A d d e n d u m

Iowa Department of Transportation
Office of Contracts

B.O.	Proposal ID	Proposal Work Type	County	Project Number	Addendum
081	94-2690-625	ALTERNATE PAVEMENT TYPES-MAINLINE PAVING	WEBSTER	STP-A-2690(625)--86-94	21JUL081.A01

TRAFFIC SIGNAL LAYOUT
 SHEET NUMBER **N.2**
 REVISED **7/16/15**

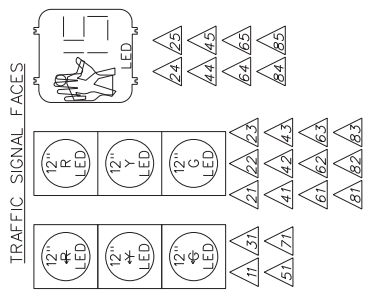
REPLACE plan sheet N.2 with the attached.

Pole #2 shall be 34'. The quantities and N sheets reflect this; however, there was one callout on sheet N.2 that was incorrect.
